Access Compliance Report

Public Rights-of-Way

(Curb Ramps)

Intersection ID: N/A	Main Street: MATTHEWS_FARM_LN	Cross Street: N/A	Location: NE
ADA ID: 360BAEBF0B5D	Ramp Type: Perp	Initial Pass/Fail: Pass	Overall Compliance: No
Severity Score: 0			
Codes/Mitigation Info/Possible Solution		Field Measurements/Component Compliance

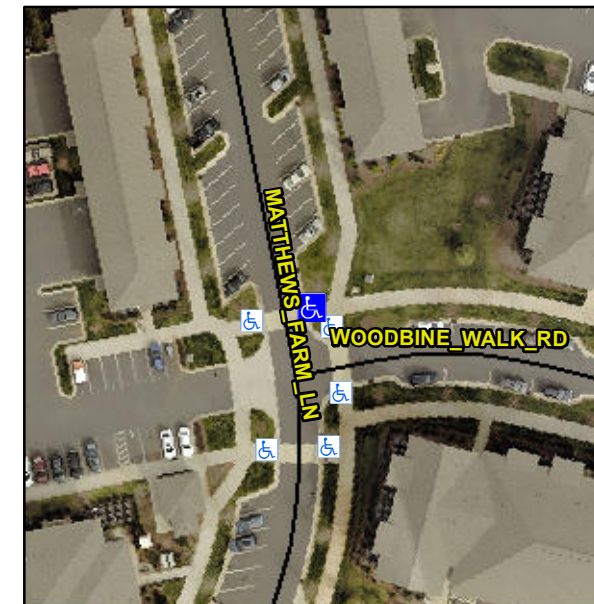
Not Found, R305.2

Remove & Replace Entire Ramp.
